FIRST AMENDMENT TO
MASTER DEED

WHITESTONE BAY CONDOMINIUM

REPLAT NUMBER 1 OF
ARENAC COUNTY CONDOMINIUM
SUBDIVISION PLAN NO. 187

SECOND AMENDMENT TO
MASTER DEED

Exhibit "1"
to First Amendment

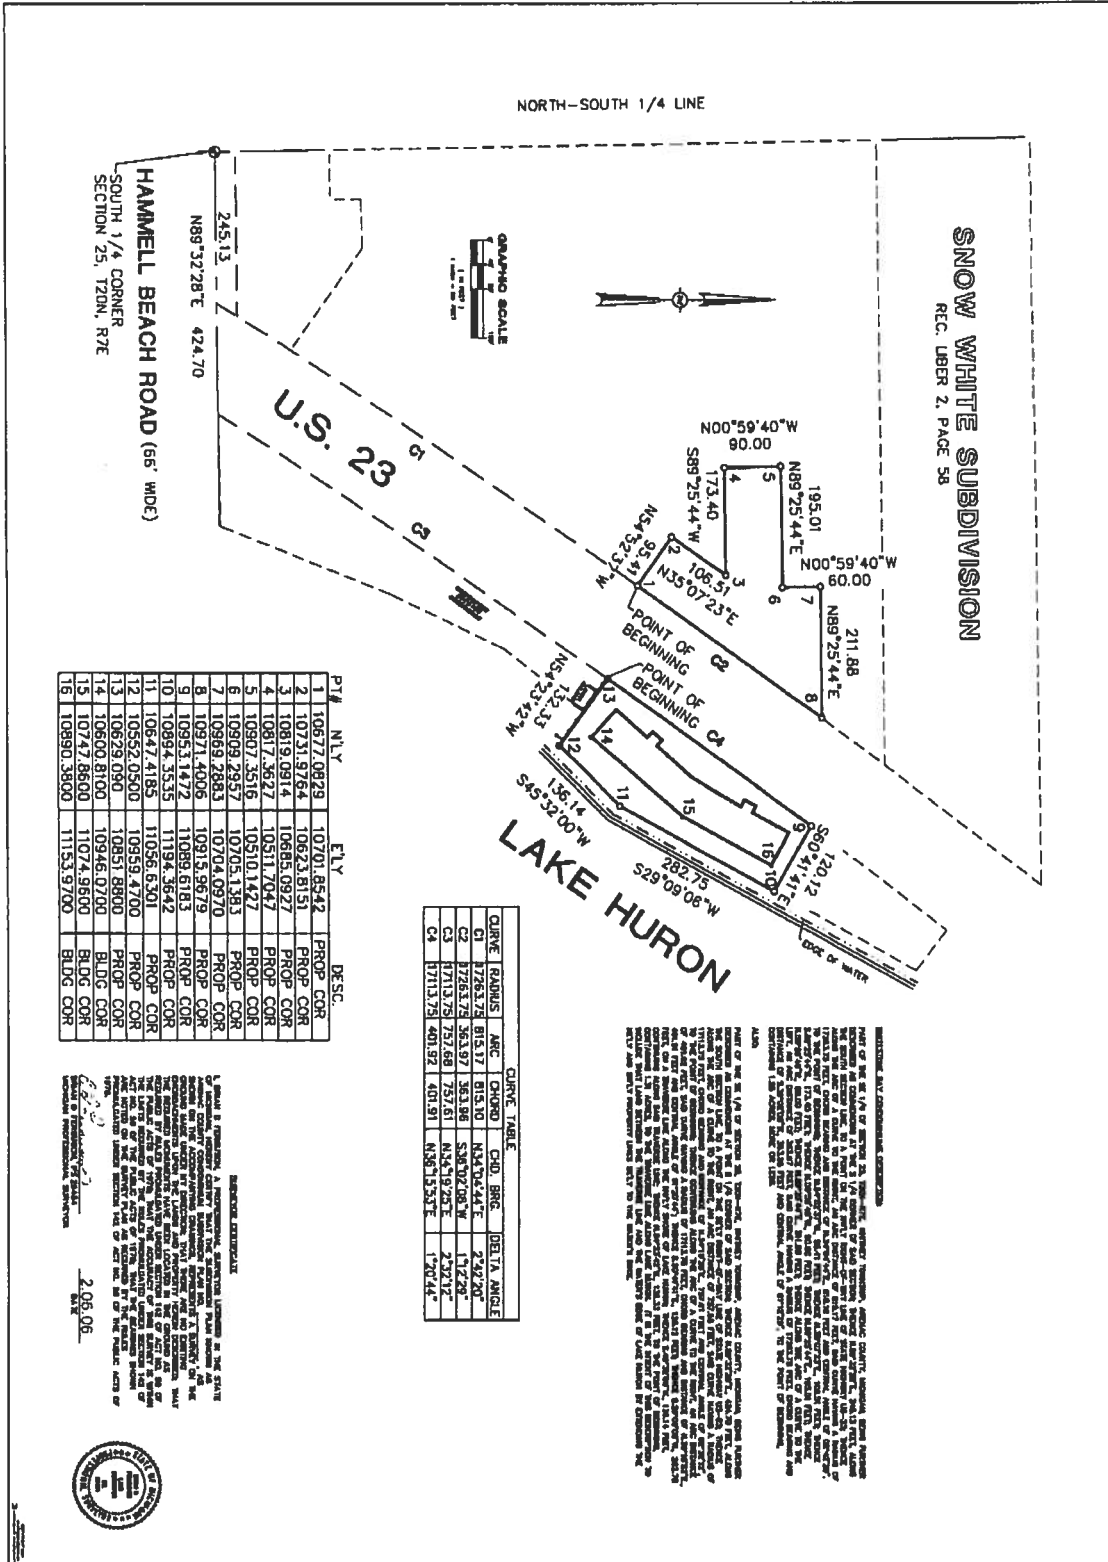
3. The Legal Description on the Title Sheet of the Condominium Subdivision Plan attached as Exhibit B to the Master Deed is amended in its entirety to read the same as the legal description set forth in Exhibit "1" to this First Amendment.

8. The legal description depicted on Exhibit C to the Master Deed is amended in its entirety to read the same as the legal description set forth in Exhibit "1" to this First Amendment.

LEGAL DESCRIPTION OF THE PROJECT

The premises situated in the Township of Whitney, County of Arenac, and State of Michigan, described as follows:

Part of the Southeast 1/4 of Section 25, Town 20 North, Range 7 East, being further described as commencing at the South 1/4 corner of said Section; thence North 89°32'28" East, 424.70 feet, along the South Section line, to a point on the Southeasterly right-of-way line of State Highway US-23; thence along the arc of a curve to the right, an arc distance of 757.68 feet, said curve having a radius of 17113.75 feet, chord bearing and distance of North 34°19'25" East 757.61 feet and central angle of 02°32'12" to the Point of Beginning; thence continuing along the arc of a curve to the right, an arc distance of 401.92 feet, said curve having a radius of 17113.75 feet, chord bearing and distance of North 36°15'53" East 401.91 feet and central angle of 01°20'44"; thence South 60°41'41" East 120.12 feet; thence South 29°09'06" West 282.75 feet, on a traverse line along the Northwestern shore of Lake Huron; thence South 45°32'00" West 136.14 feet, continuing along said traverse line; thence North 54°23'42" West 132.33 feet, to the Point of Beginning, containing 1.31 acres, to the traverse line along Lake Huron. It is the intent of this description to include that land between the traverse line and the water's edge of Lake Huron by extending the Northeasterly and Southwesterly property lines Southeasterly to the water's edge,

Also,

Part of the Southeast 1/4 of Section 25, Town 20 North, Range 7 East, being further described as commencing at the South quarter corner of said Section; thence North 89°32'28" East, 245.13 feet, along the South Section line, to a point on the Northwestern right-of-way line of State Highway US-23; thence along the arc of a curve to the right, an arc distance of 815.17 feet, said curve having a radius of 17263.75 feet, chord bearing and distance of North 34°04'44" East, 815.10 feet and central angle of 02°42'20", to the Point of Beginning; thence North 54°52'37" West, 95.41 feet; thence North 35°07'23" East, 106.51 feet; thence South 89°25'44" West, 173.40 feet; thence North 00°59'40" West, 90.00 feet; thence North 89°25'44" East, 195.01 feet; thence North 00°59'40" West, 60.00 feet; thence North 89°25'44" East, 211.88 feet; thence along the arc of a curve to the left, an arc distance of 363.97 feet, said curve having a radius of 17263.75 feet, chord bearing and distance of South 36°02'08" West, 363.96 feet and central angle of 01°12'29" to the Point of Beginning, containing 1.25 acres, more or less. Together with a 50 foot wide easement for ingress/egress lying adjacent to and immediately North of the above described parcel. Said Easement to extend Easterly to the Northwestern line of US-23.
